March 19, 2026

**Re: 13 Mountain Street and 19-23 Elm Street – ZBA & OPA Resubmission,  
Response to Town Comments**

## 8.0 RESPONSE TO TOWN COMMENTS

**FIGURE 1 EXISTING STREET NETWORK**

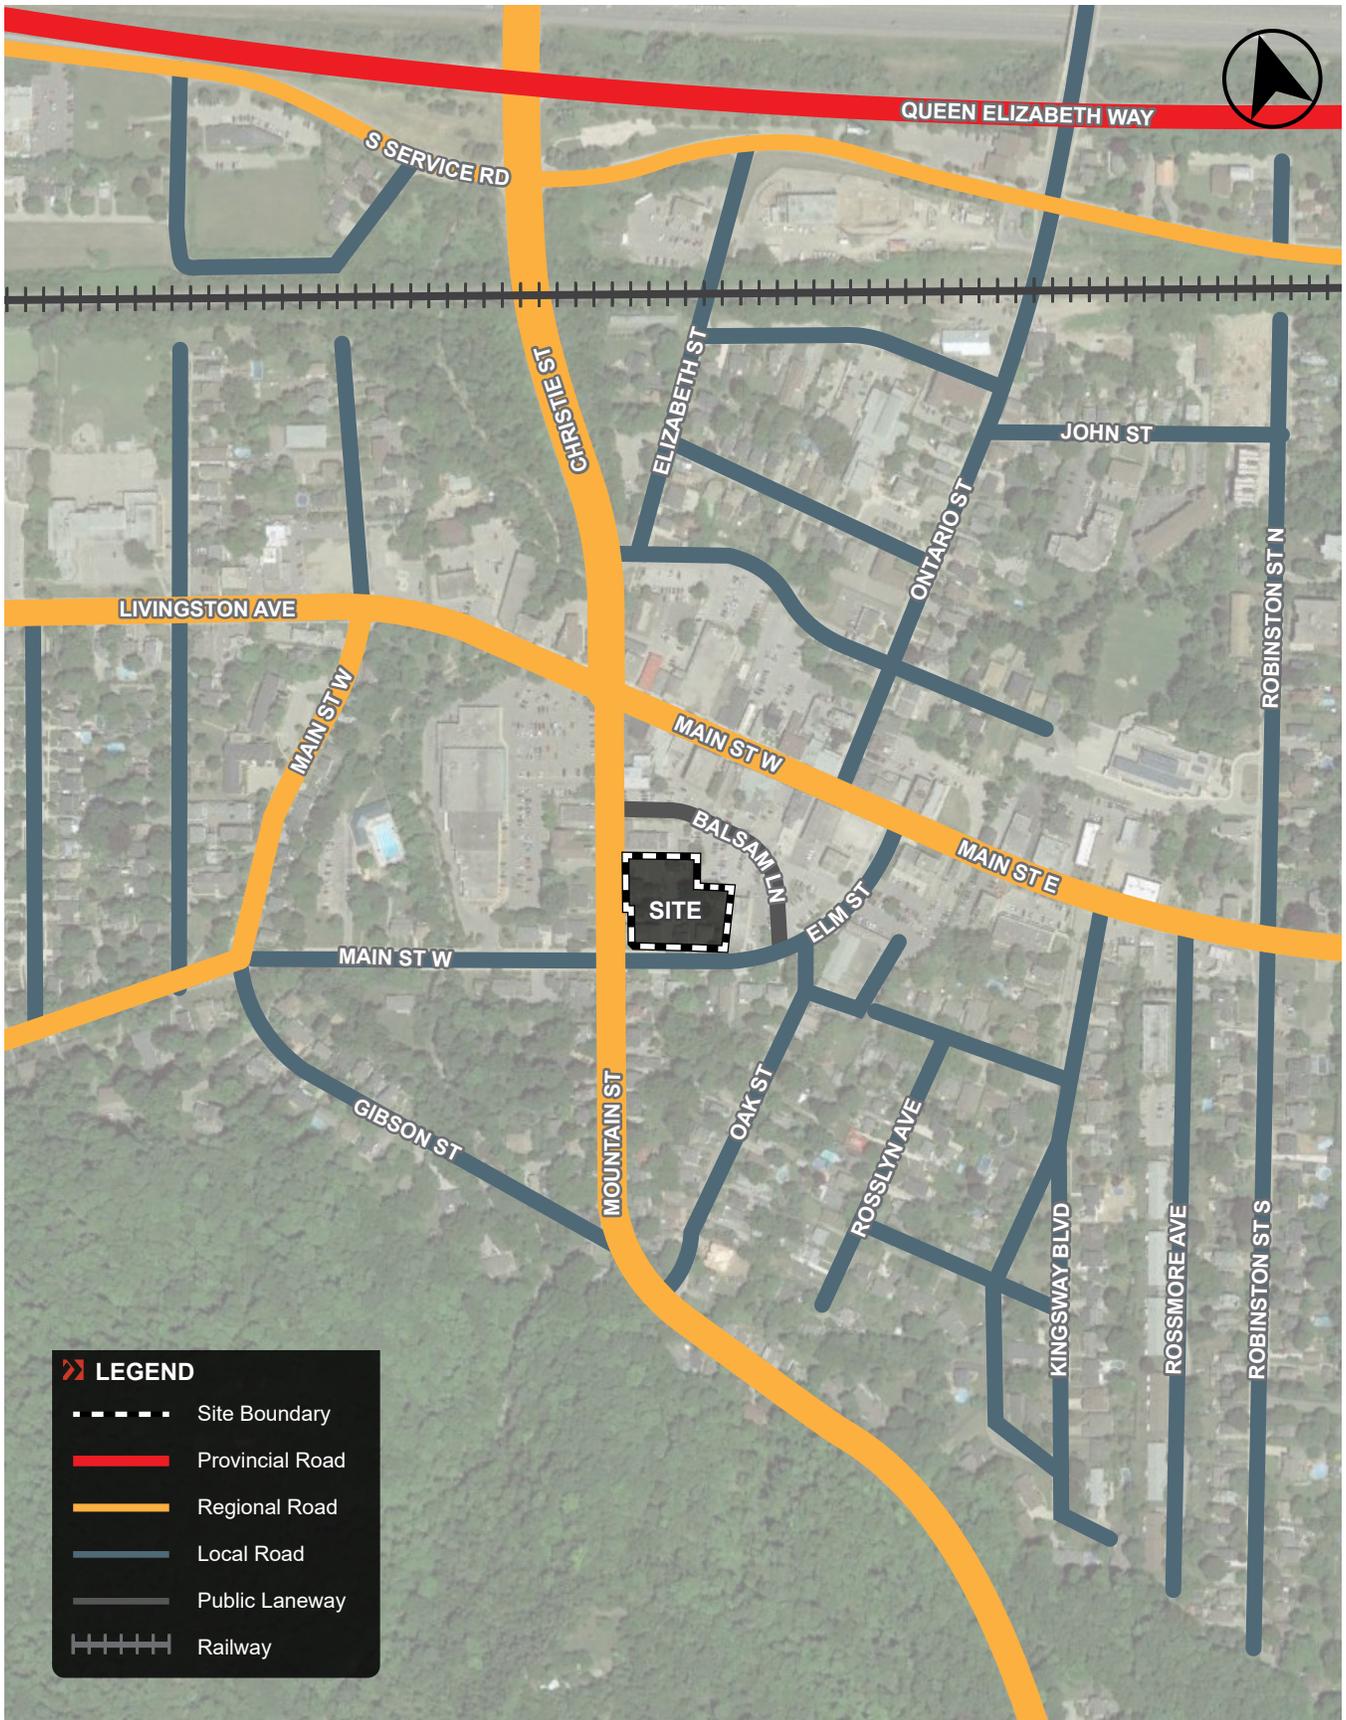
*Table 2 and Figure 3 identify Balsam Lane as a local road. Balsam Lane is not a local road, but a public laneway. Please update accordingly.*

Noted. **Table 13** and **Figure 1** have been updated to note Balsam Lane as a public laneway.

**SITE PLAN**

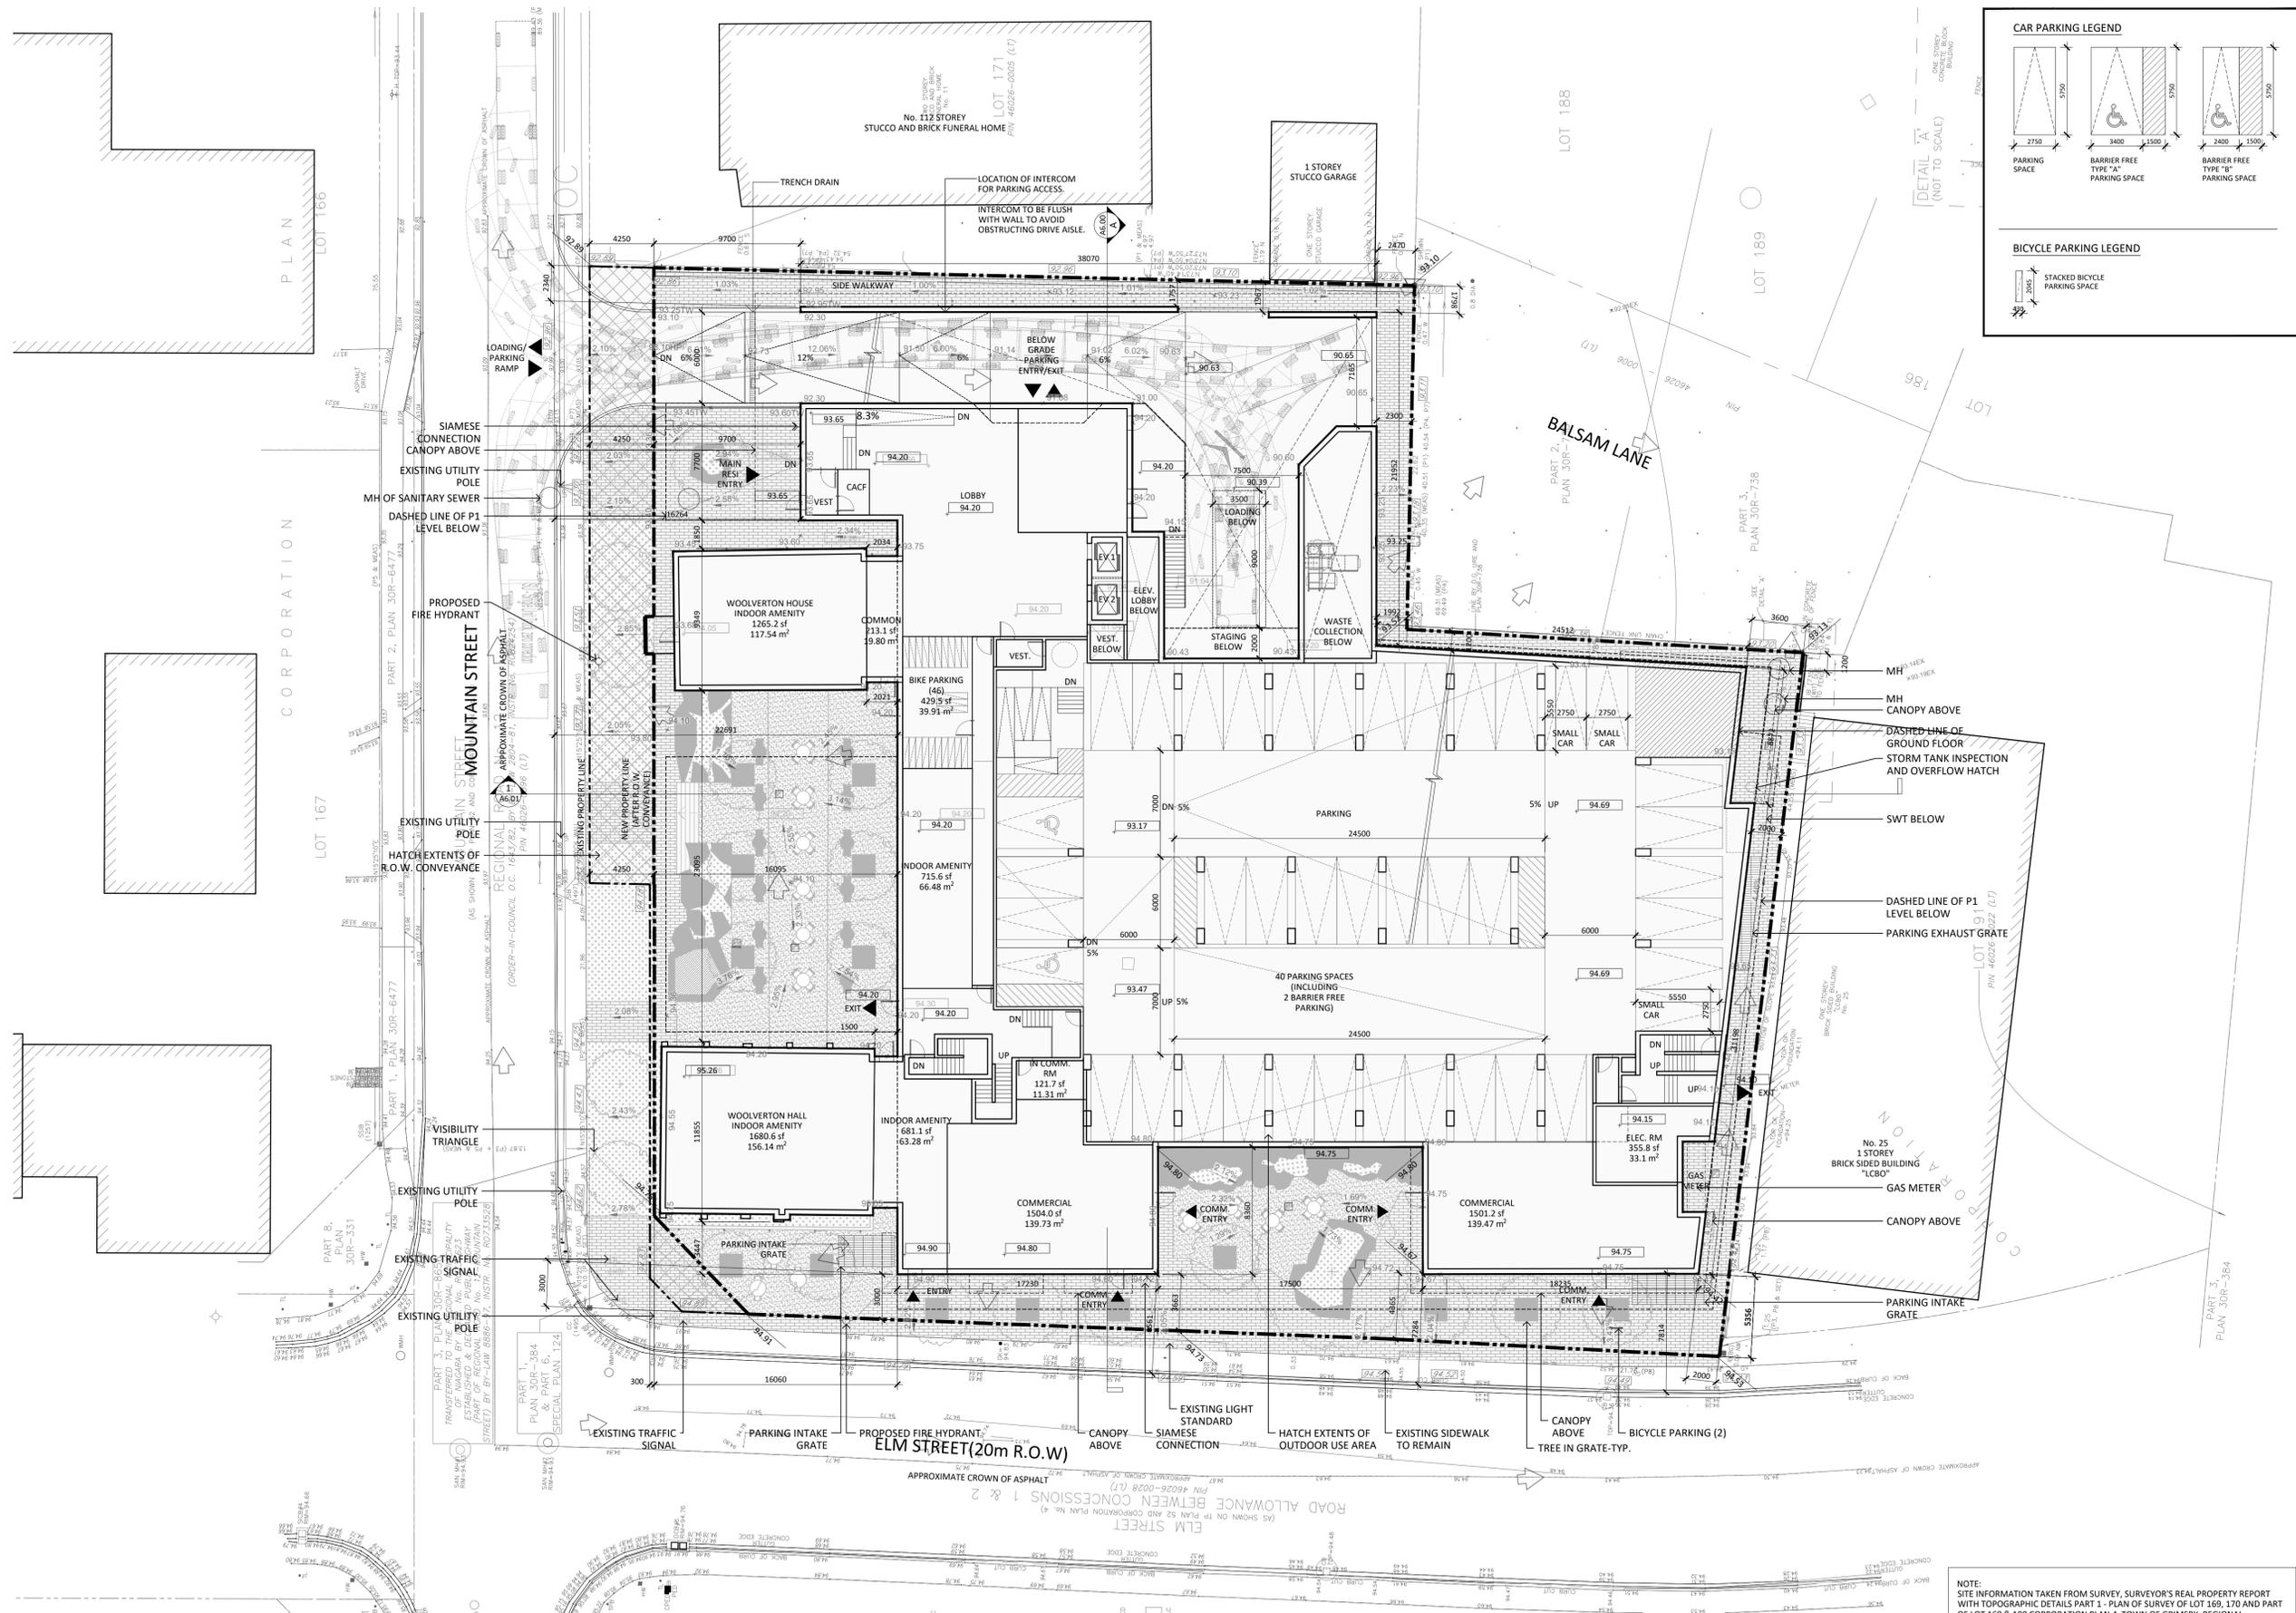
*The Town's Zoning By-Law requires a minimum clear and unobstructed vertical clearance of 4.5 m for refuse truck maneuvering, including the path of travel and the loading area itself. Based on the elevation plan, the driveway appears to be less than 4.5 m. Please confirm that the full path of travel for the refuse truck including entry, exit, and the loading bay meets the minimum requirement.*

Noted. The proposed loading area has a minimum vertical clearance of 4.5-metres for refuse truck maneuvering, as illustrated in the updated site plan provided in **Appendix A**. Further details will be provided during the future Site Plan Approval process.

**13 MOUNTAIN STREET, GRIMSBY**  
**SMALL CAR PARKING INVENTORY**  
**INTERMEDIATE FLOOR**

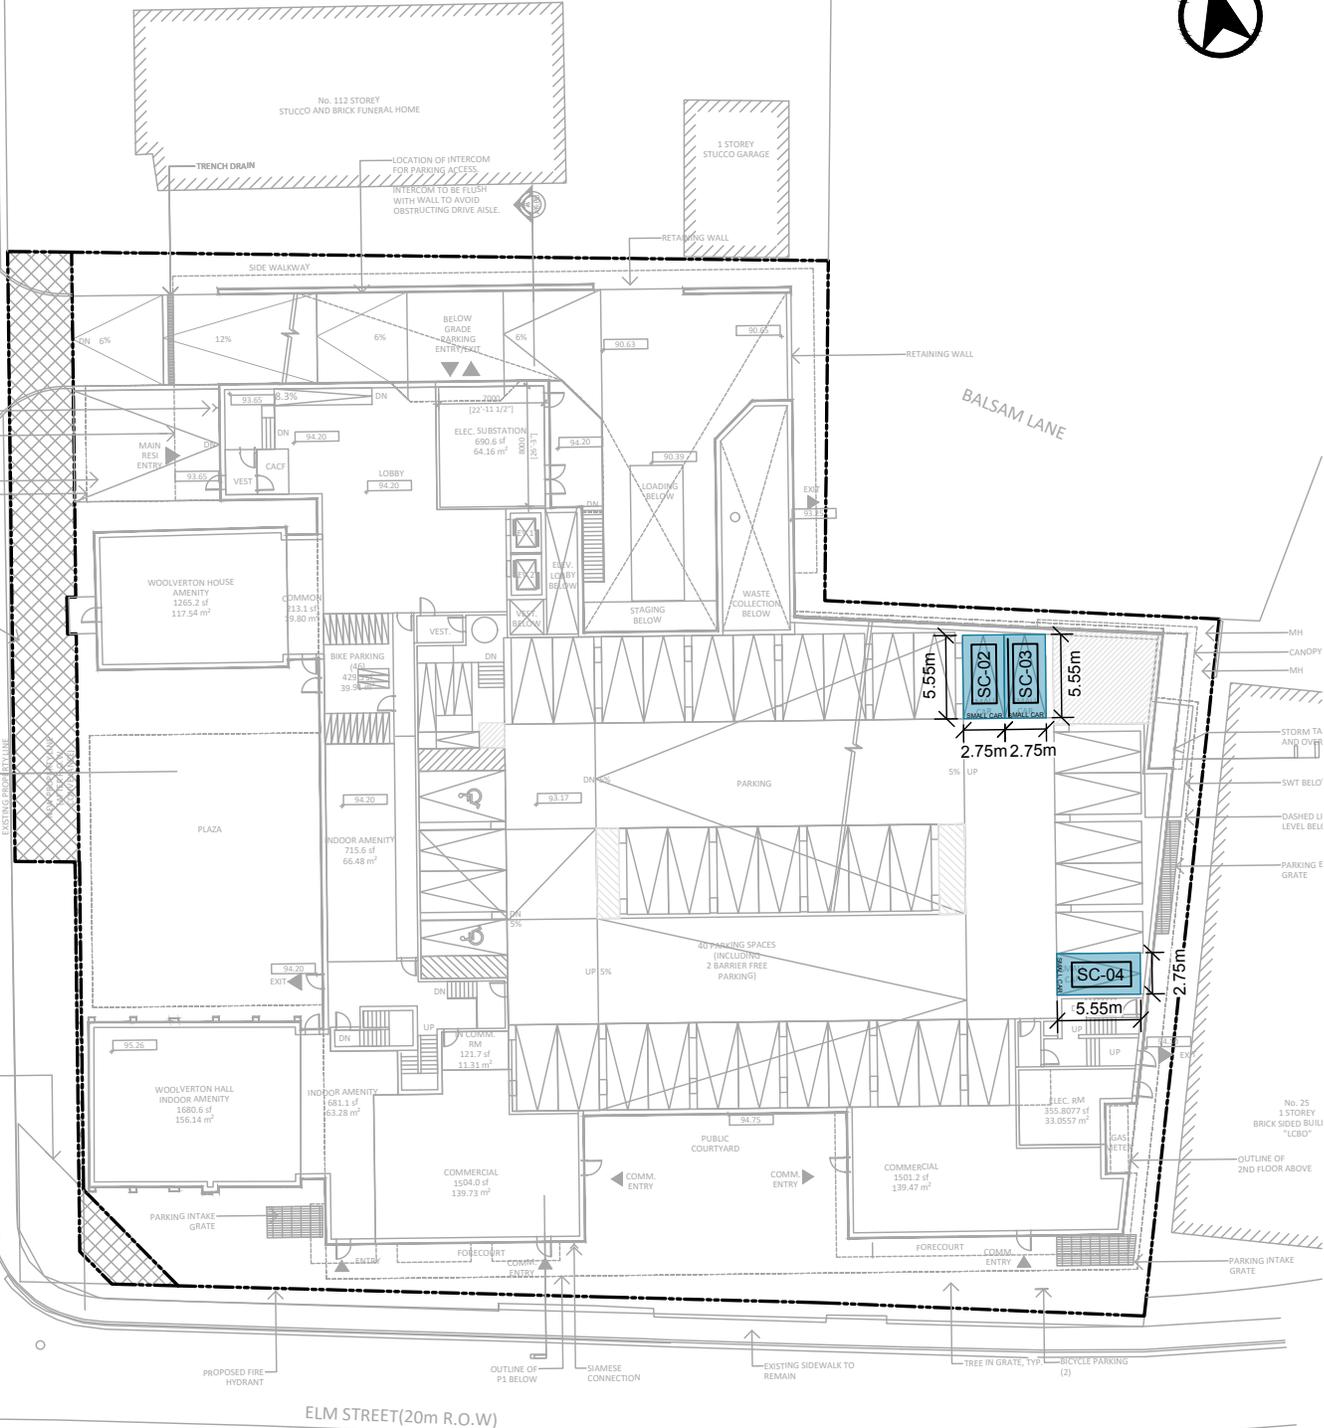
*The proposed residential parking supply includes eight small car spaces. As these spaces do not meet the minimum dimensional requirements of the Town's Zoning By-Law, they should not be counted toward the overall parking supply. Please revise the proposed parking supply accordingly.*

The current plans have been revised, and as a result of the design development changes the number of non-standard parking spaces has been reduced compared to the May 2025 submission. The proposal currently includes 5 non-standard parking spaces which represents 3% of the overall parking supply, inclusive of:

## 13 MOUNTAIN STREET, GRIMSBY VEHICULAR MANOEUVRING DIAGRAM INTERMEDIATE FLOOR - TURNAROUND

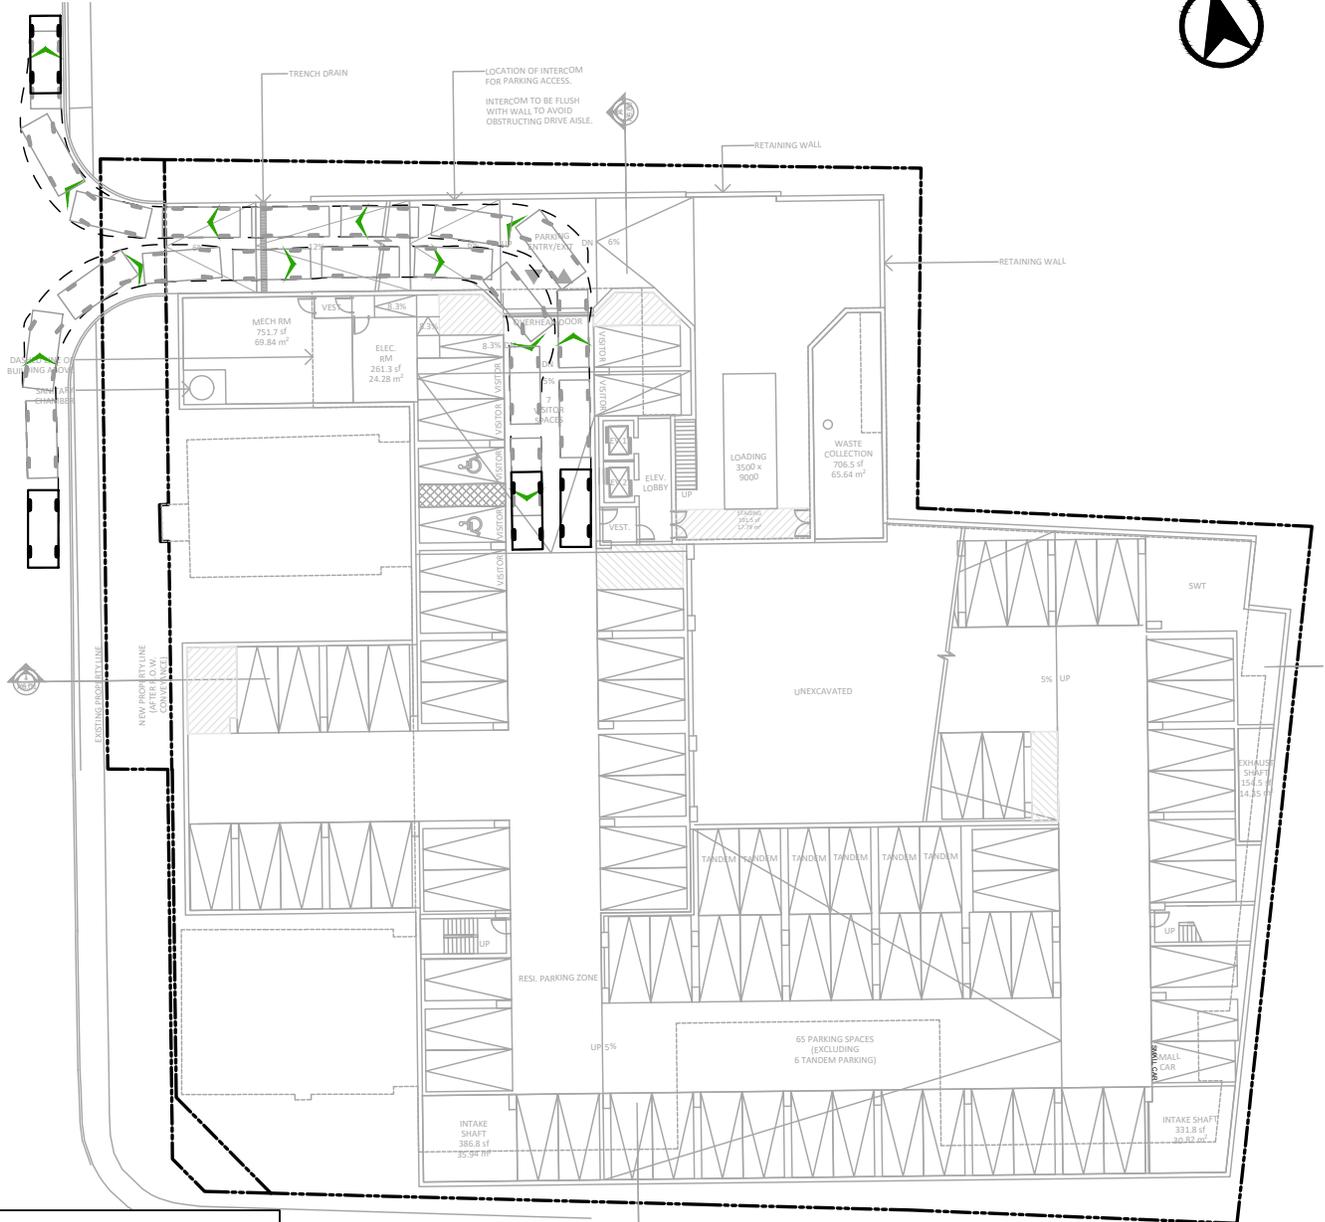
*The site plan includes a dead-end configuration near the residential parking gate, intermediate floor level and visitor parking. Please provide swept path analysis to demonstrate that a passenger vehicle can turn around.*

The gate separating the visitor / commercial and residential parking area has been removed from the updated plans. The current proposal is to sign the visitor / commercial parking spaces as “visitor parking spaces only” spaces and provide a turnaround space that will allow for vehicles to turnaround in case all the spaces are occupied. Please refer to vehicle manoeuvring diagrams VMD-05 to VMD-06 in **Appendix E**.
